# Tree location errors in the Chartford Homes Drawings

## Tree Survey Drawing

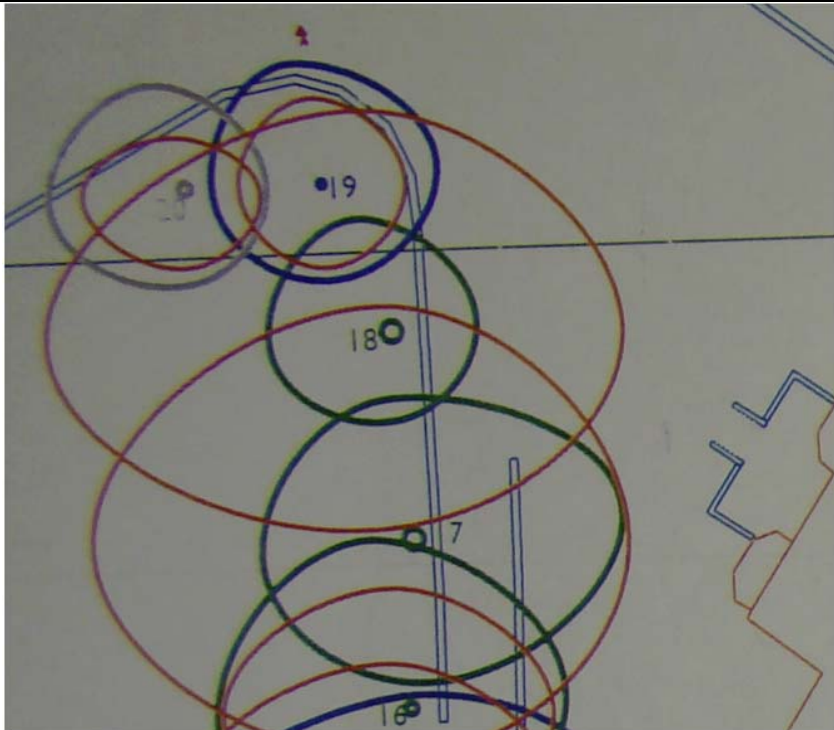
- All trees are shown correctly located.
- Tree canopies shown bold.
- Root spreads shown orange.

## Development Plan

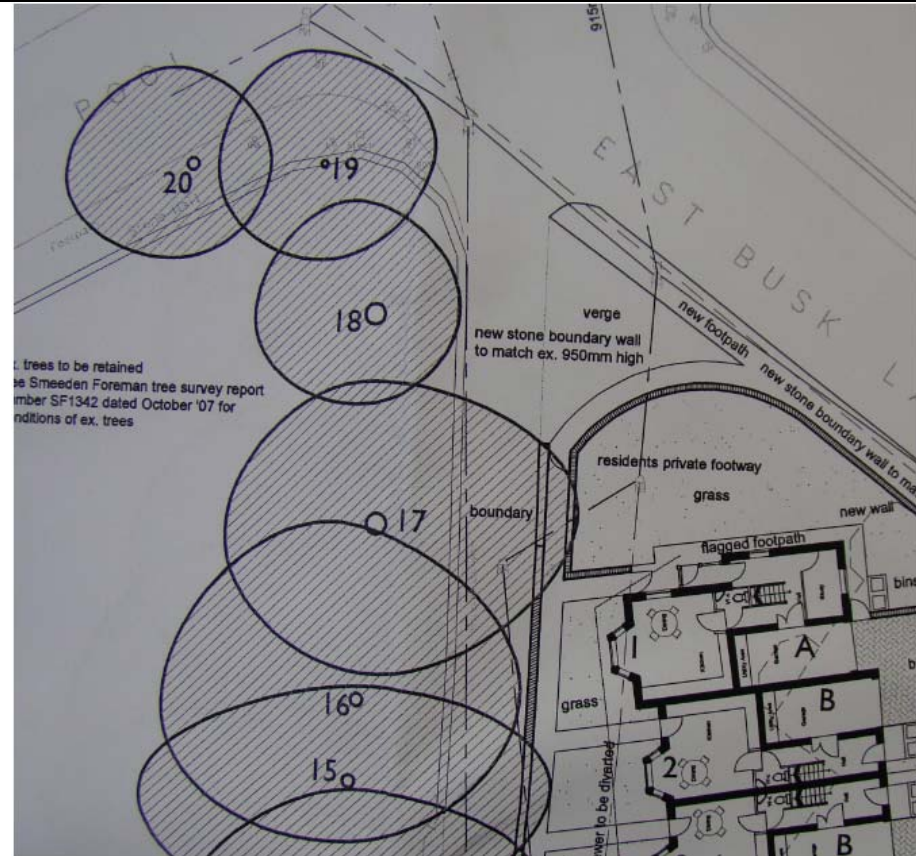
- Tree 20 is shown in the footpath on Pool Road.
- Park trees miss-placed 5m towards Pool Road.
- Root spreads not shown.
